KNOXVILLE HISTORIC ZONING COMMISSION STAFF REPORT - CERTIFICATE OF APPROPRIATENESS APPLICATION

PROPERTY ADDRESS: 412 E Scott Ave 37917

FILE NO.: 2-B-18-HZ

MEETING DATE: 2/15/2018

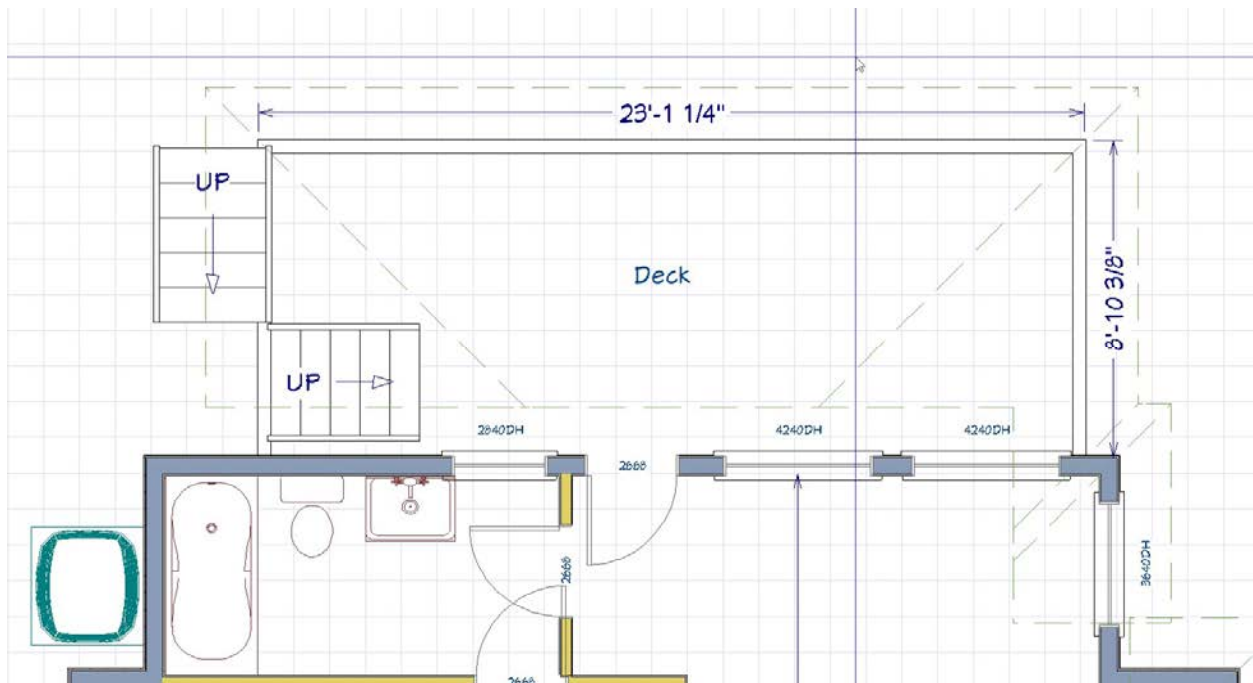
3). There is evidence in the engaged half-round column existing on the porch to indicate the design of the proposed porch columns. A balustrade may have turned or 2x2 straight pickets.

Columns on front porch – Remove metal posts and railings and replace with wooden columns and balustrade. Picture of proposed columns included, antique approximately 8" width similar to the 2 existing half columns on front of house.

- Approve new porch balustrade on condition that a design drawing be submitted.
- Approve porch columns on condition that design be submitted for capitals.
- Approve new siding based on the original having already been replaced, and the new siding matching the existing siding to be retained on the north side.
- Approve rear deck.
- Approve replacement wood half-light rear door as existing door is not original and not appropriate.

412 E. Scott - Current status of south facade as viewed from south

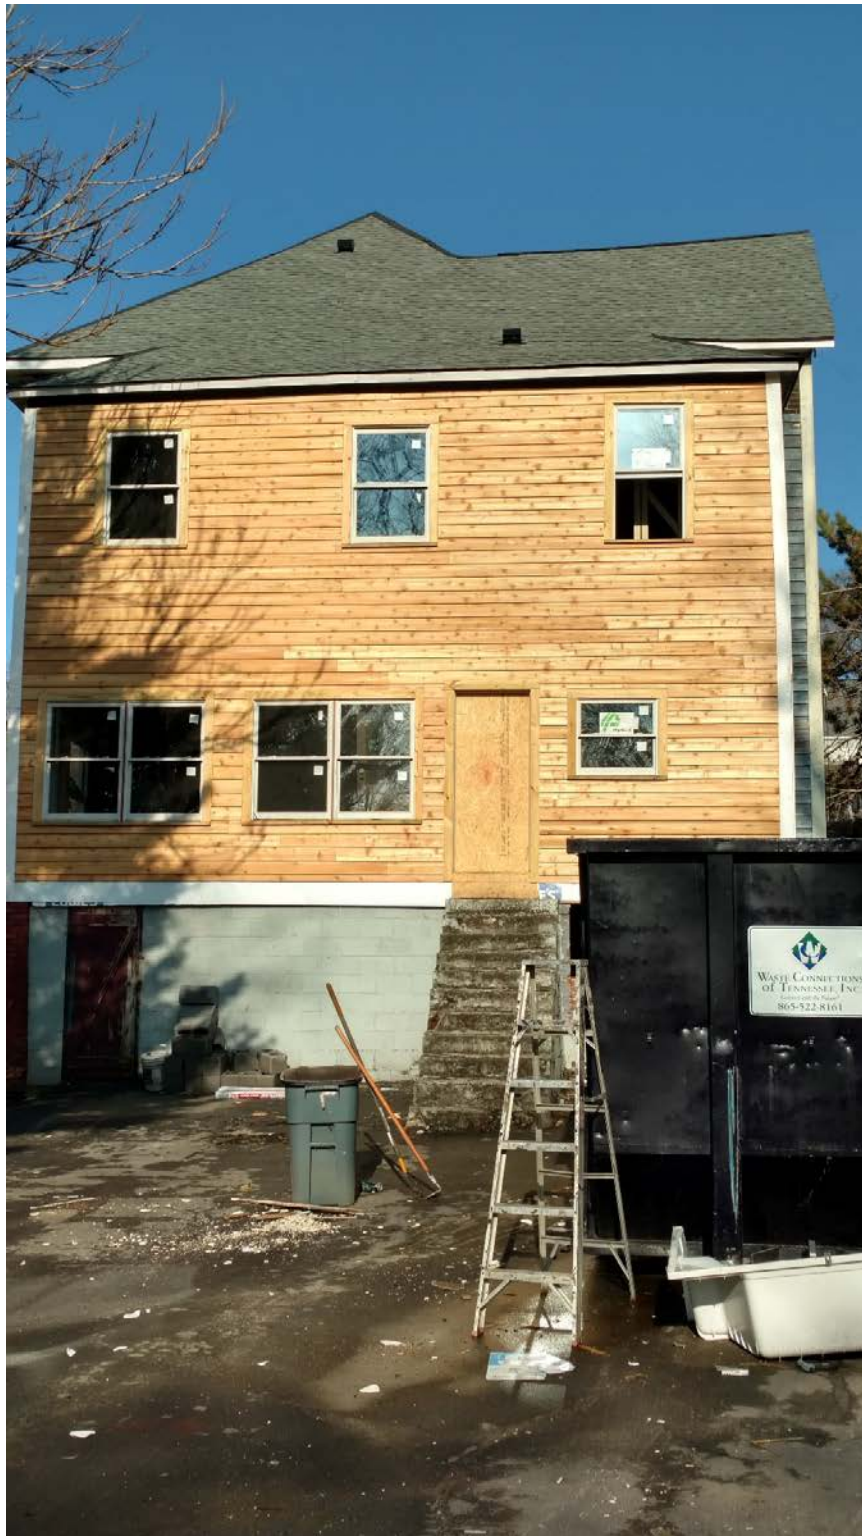
5) The 6"-siding on the south and rear was found to be more deteriorated than originally thought; therefore, instead of repairing and replacing as needed, the entire south and rear walls of sheathing and siding were replaced to match previously existing. The 6-inch replacement siding does not abut the 4-1/2 " siding on the front corner.

- 8) Two of the existing windows on the south side toward the front of the house were blocked in when the wall was re-sheathed and sided. One was a horizontally-oriented decorative window and the other a 1/1 double-hung.

- 1) Re-construct the two windows on the south side that were blocked in, based on earlier Google earth photo. Muntin pattern to be confirmed as appropriate.
- 2) Re-construct the south side upper level window closest to front of house (westernmost) to be the same size as, and align with, the window to the east.
- 3) Install 1/1 wood windows to fit the original openings as indicated by the existing framing on all of the street-level windows on the north side.
- 4) Replace the small square double-hung window on the rear of the house toward the north side with square wood casement or stationary window as it is out of historic proportion. Consider aligning it with the window above.
- 5) Deny installation of 1/1 egress window in attic gable on north side.
